Project	IEEE 802.16 Broadband Wireless Access Working Group < <a href="http://ieee802.org/16">http://ieee802.org/16</a> >
Title	Addition of SS Basic Capability Negotiation in Network Entry Management
Date Submitted	2007-01-12
Source(s)	Jee Hyeon Na, ETRI, E-mail: <a href="mailto:jhna@etri.re.kr">jhna@etri.re.kr</a> Jaesun Cha, ETRI, E-mail : <a href="mailto:jscha@etri.re.kr">jscha@etri.re.kr</a> JungMo Moon, PhD, ETRI, E-mail: <a href="mailto:jmmoon@etri.re.kr">jmmoon@etri.re.kr</a> Mi-Young Yoon, ETRI, E-mail: <a href="mailto:myyun@etri.re.kr">myyun@etri.re.kr</a> Sang Ho Lee, PhD, ETRI, E-mail: <a href="mailto:leesh@etri.re.kr">leesh@etri.re.kr</a> Yun Won Chung, PhD, Soongsil University, E-mail: <a href="mailto:ywchung@ssu.ac.kr">ywchung@ssu.ac.kr</a>
Re:	Call for Comment on P802.16g D6 Document
Abstract	This contribution proposes service primitives for network entry.
Purpose	The document should be considered during the resolution of comments on the D6 document.

# Addition of SS Basic Capability Negotiation in Network Entry Management

Figure xxx – SS Basic Capability Negotiation Primitives (MS and BS)

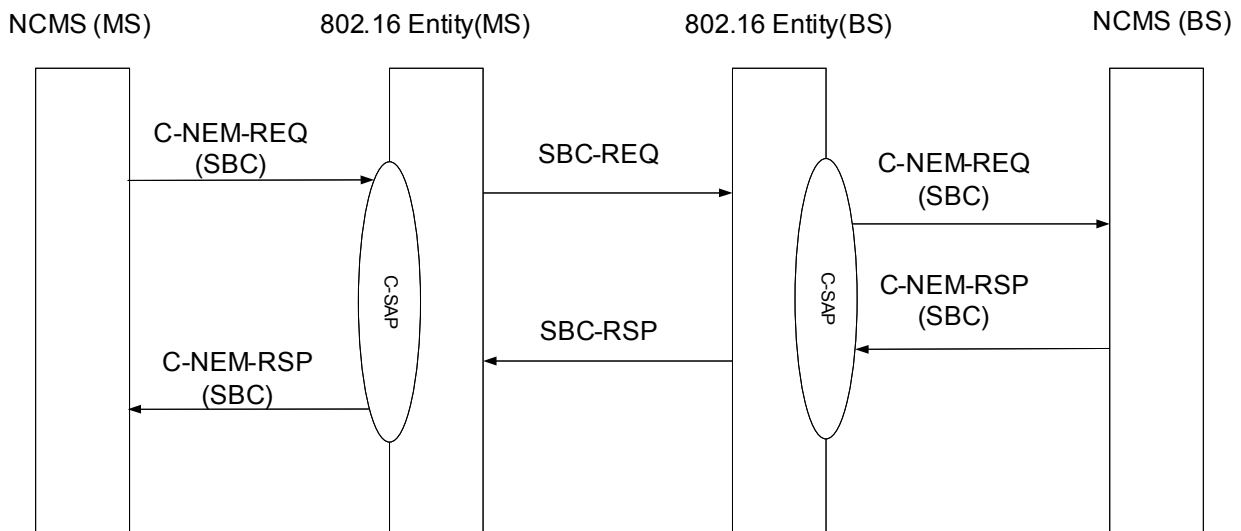
In Section 14.2.7, network entry management is described, where network entry procedure consists of ranging, registration, and network attachments. The current network entry management, however, does not contain SS basic capability negotiation during initial network entry. Since NCMS (MS) does not know when it should generate C-NEM-REQ(registration) primitive without indication from 802.16 Entity(MS) because it does not know whether SS basic capability negotiation procedure in MAC layer is completed or not, SS basic capability negotiation should be included for network entry management procedures. Thus, in this contribution, we propose to add SS basic capability negotiation primitives and related procedures in Section 14.2.7.

[Inserts the following figure between figure 498 and figure 499 in Section 14.2.7.1 ]
